# CORBA PV Bicyclist Trail Recommendations

## Concerned Off-road Bicyclists Association Palos Verdes

Accept PUMP recommendations with suggested changes.

# CORBA PV Suggested changes from PUMP

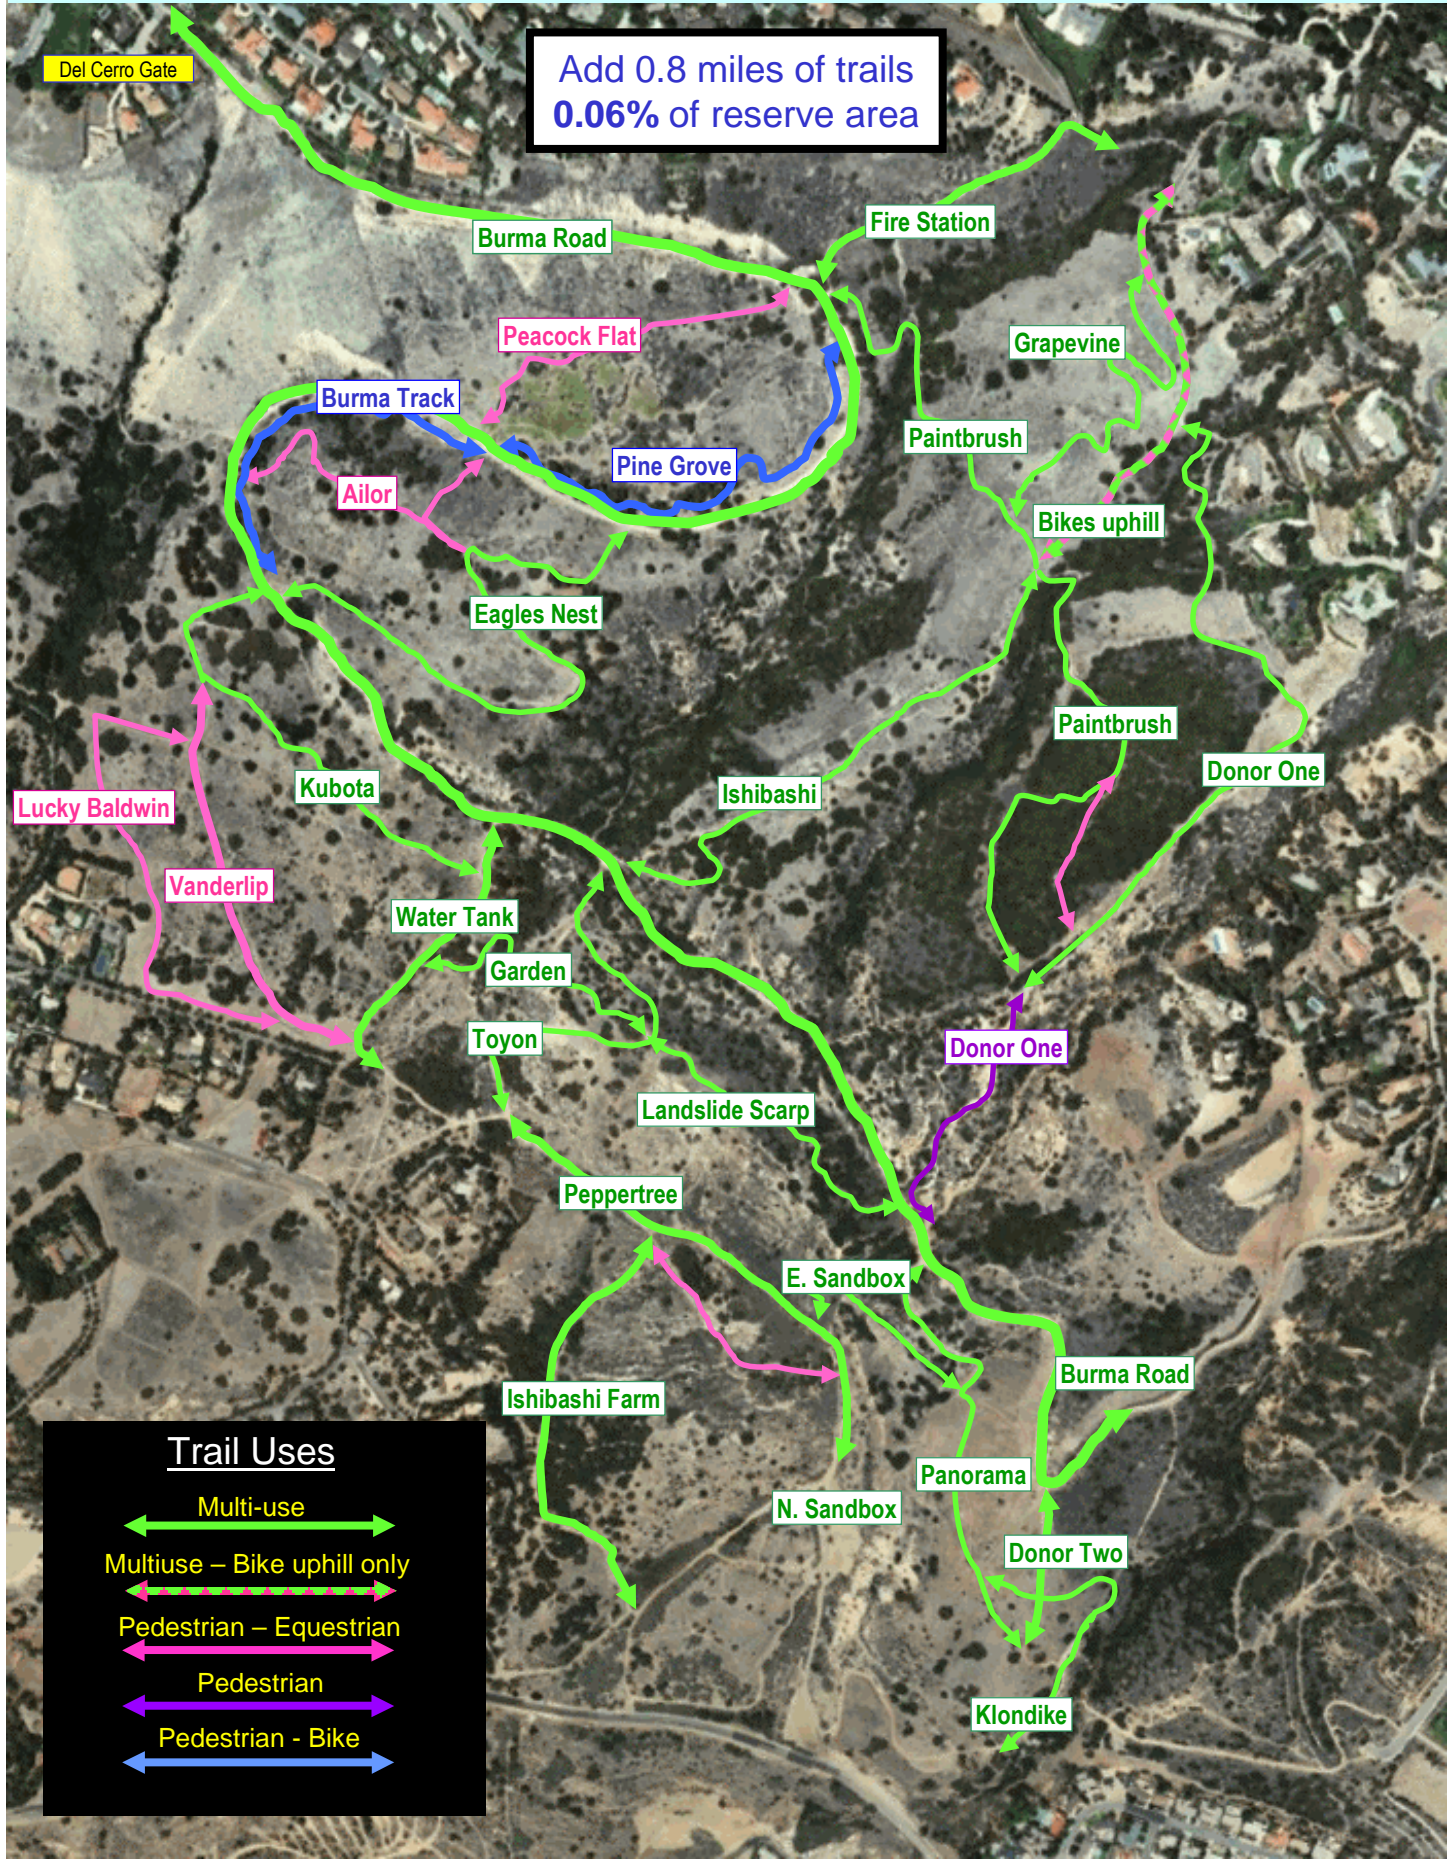
Add 0.8 miles of trails  
0.06% of reserve area

# CORBA PV - change to multi-use

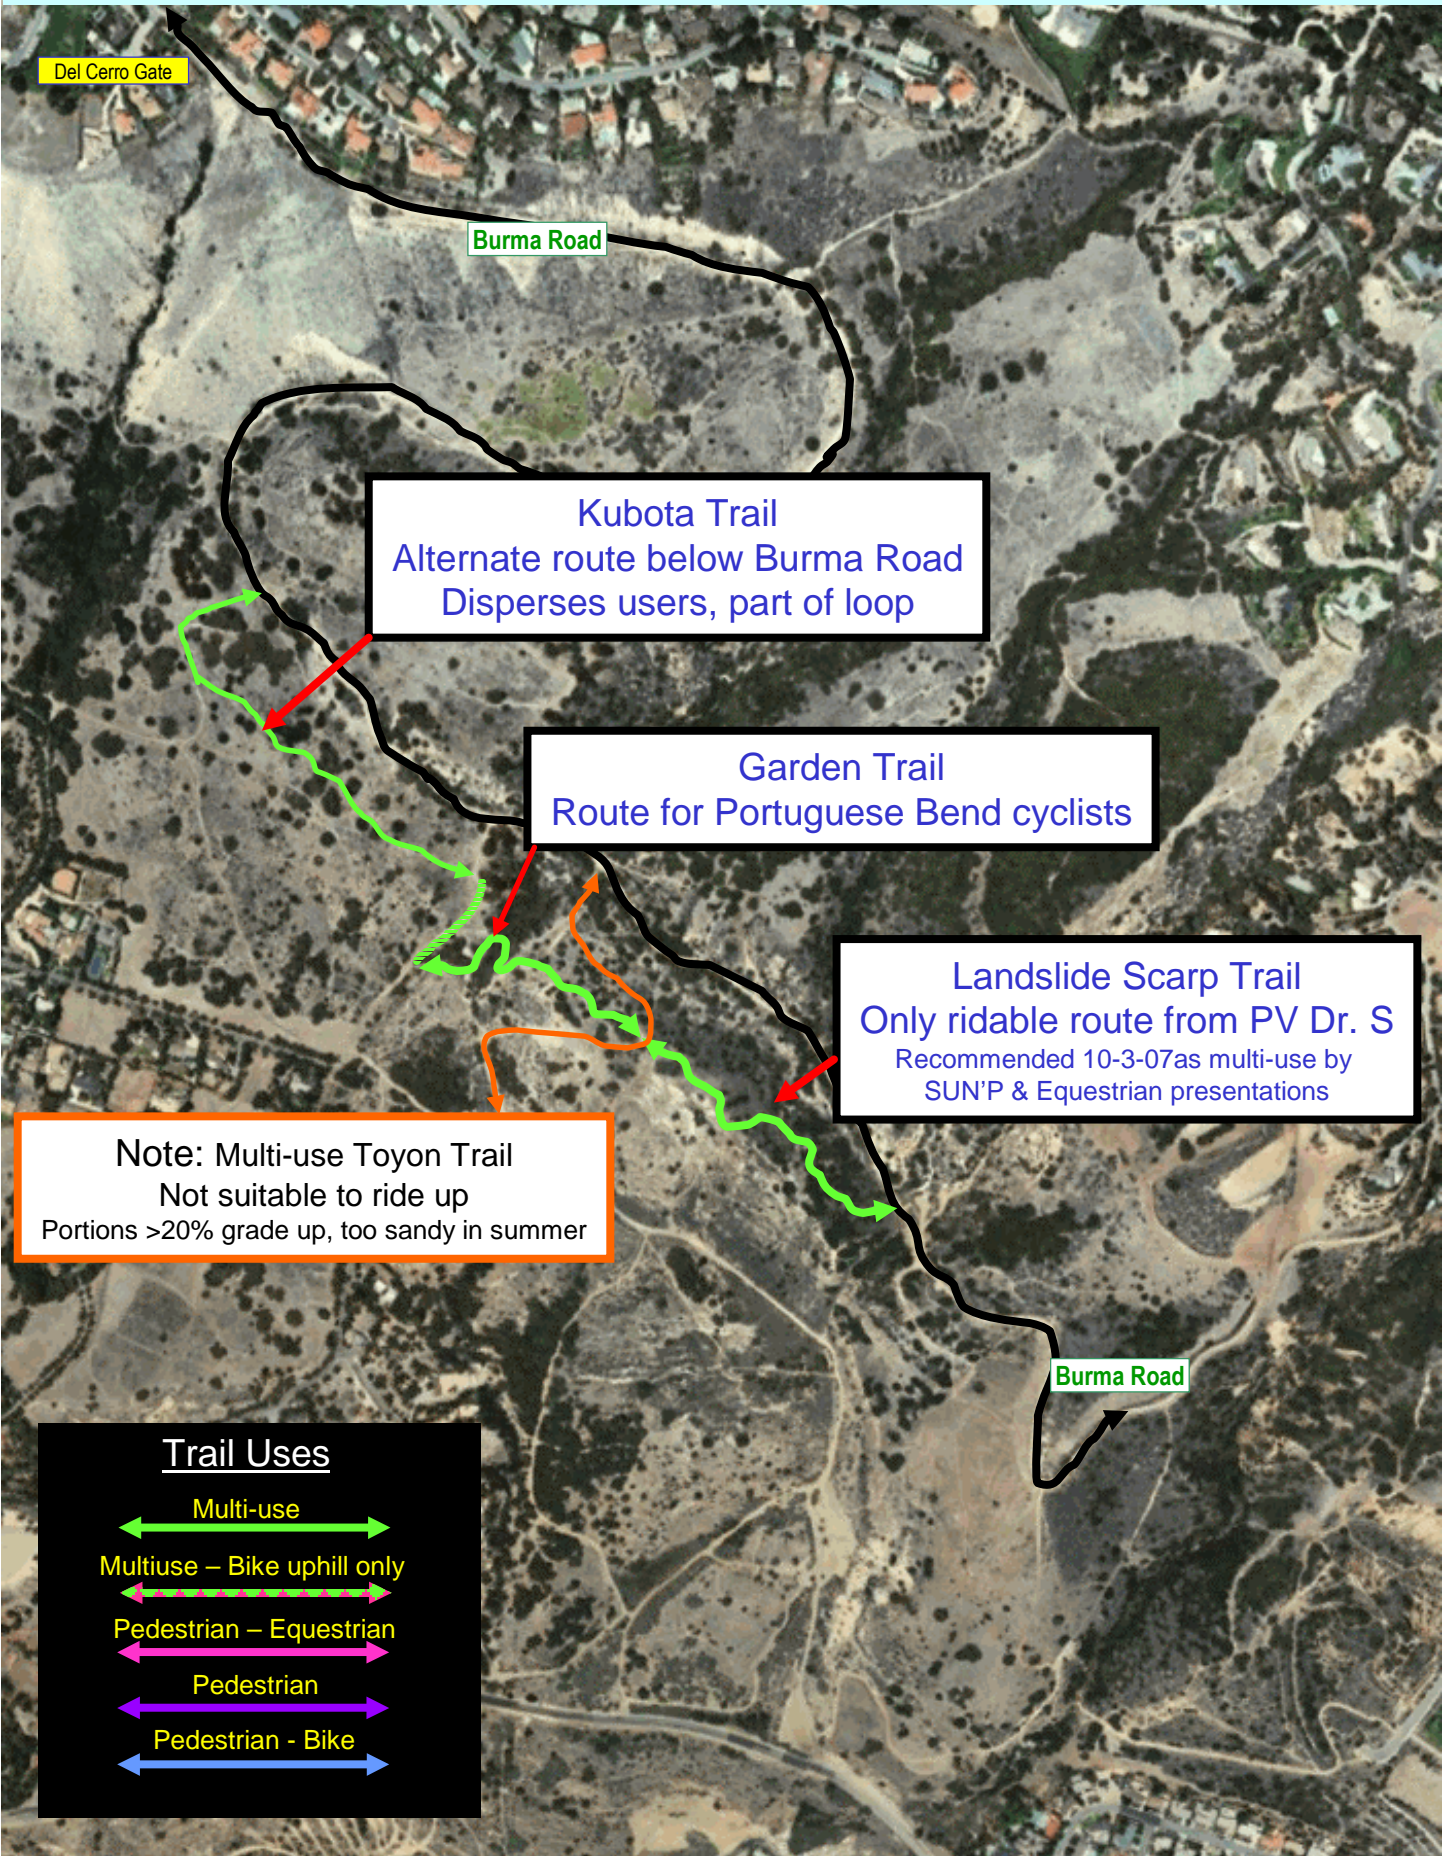
**Kubota Trail**  
Alternate route below Burma Road  
Disperses users, part of loop

**Garden Trail**  
Route for Portuguese Bend cyclists

**Landslide Scarp Trail**  
Only rideable route from PV Dr. S  
Recommended 10-3-07 as multi-use by  
SUN'P & Equestrian presentations

Note: Multi-use Toyon Trail  
Not suitable to ride up  
Portions >20% grade up, too sandy in summer

# CORBA PV - change to multi-use

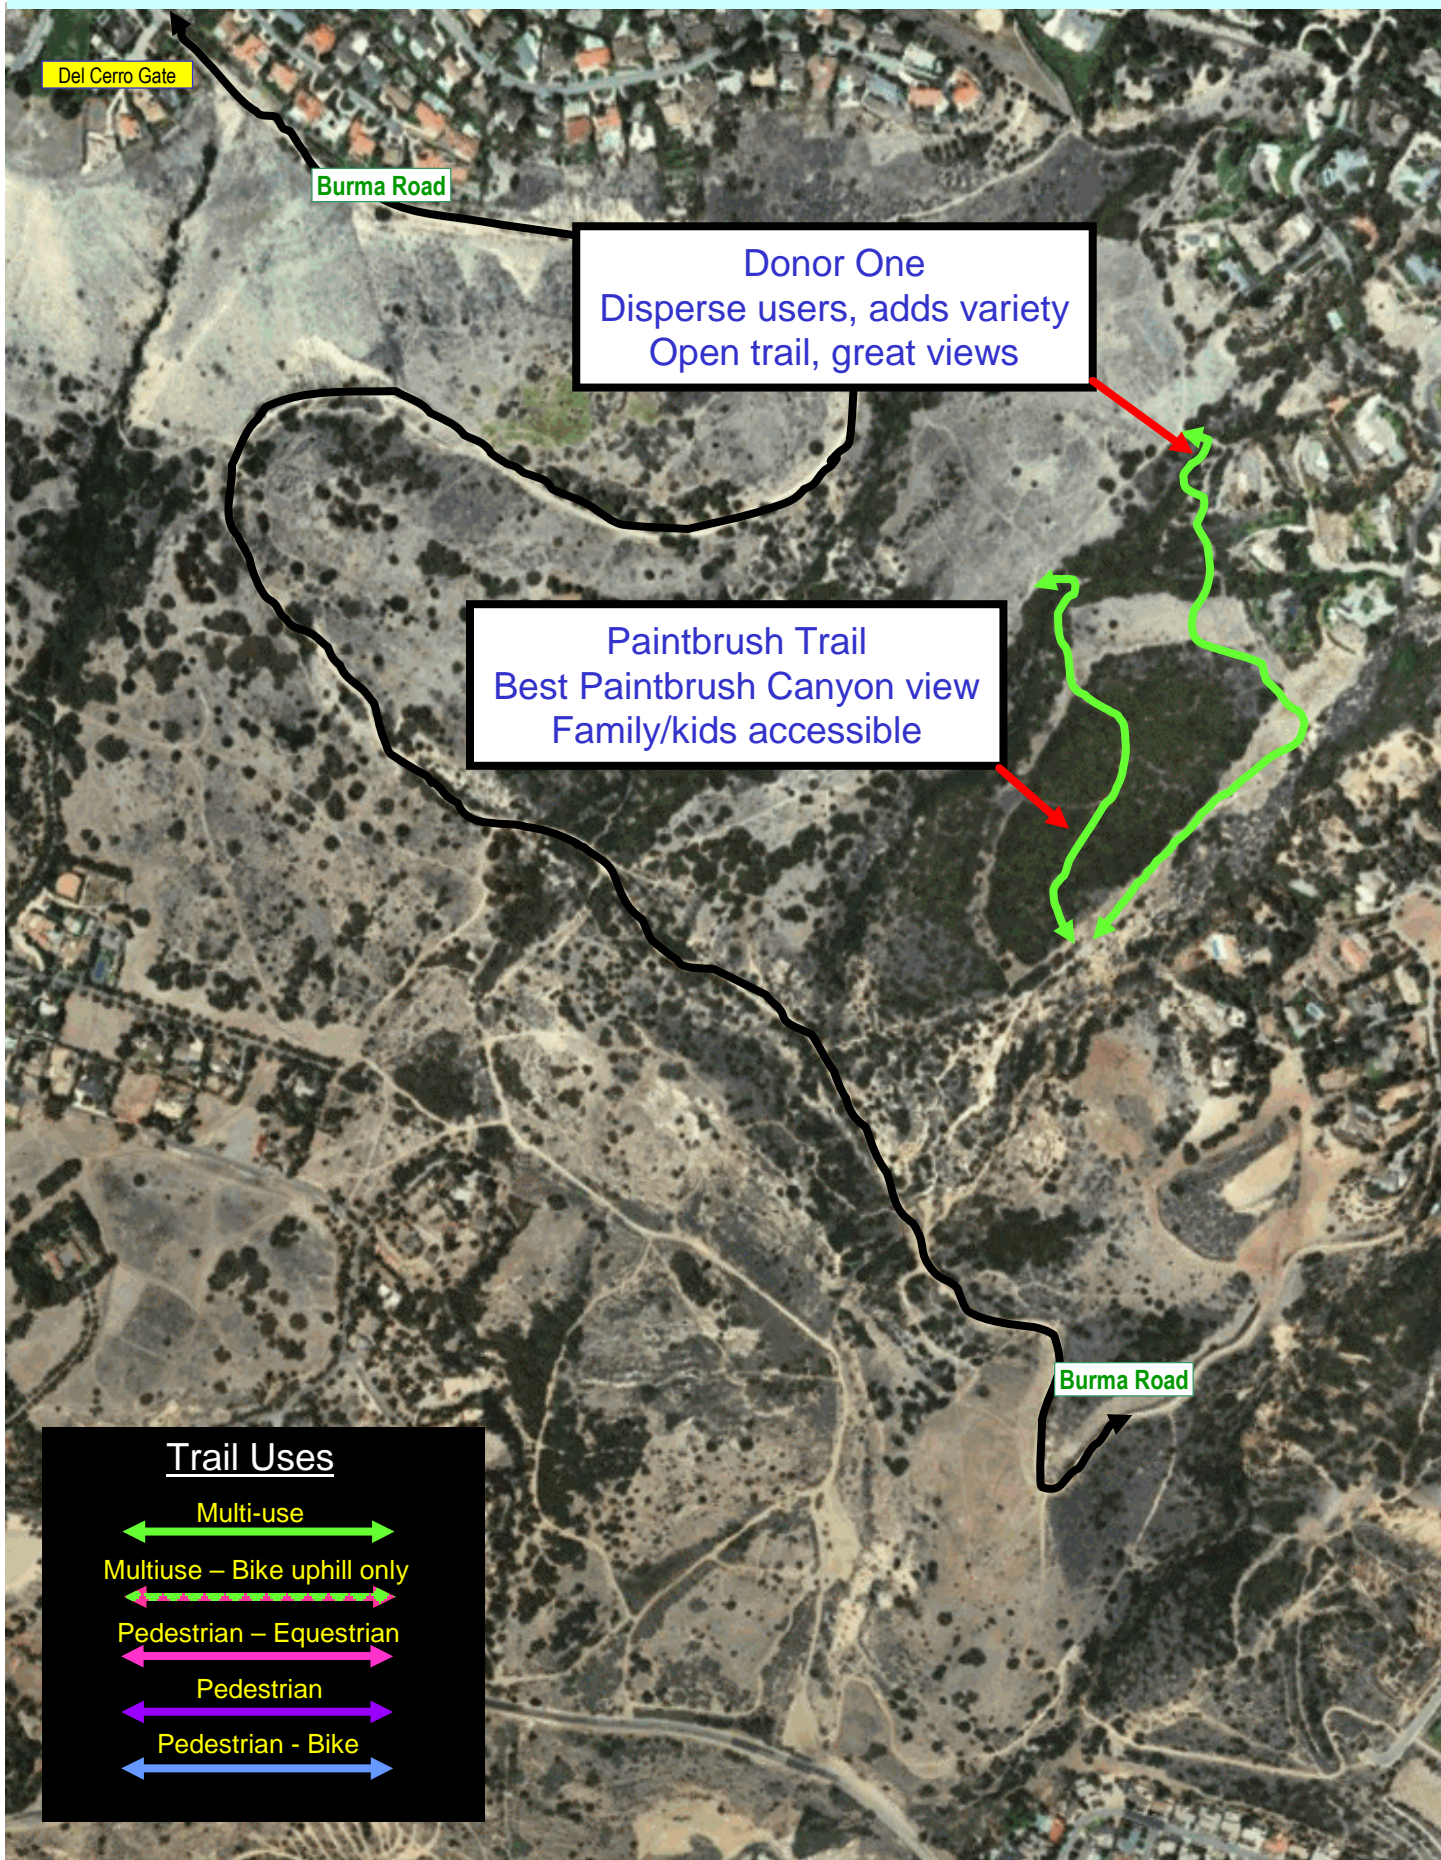
Donor One  
Disperse users, adds variety  
Open trail, great views

Paintbrush Trail  
Best Paintbrush Canyon view  
Family/kids accessible
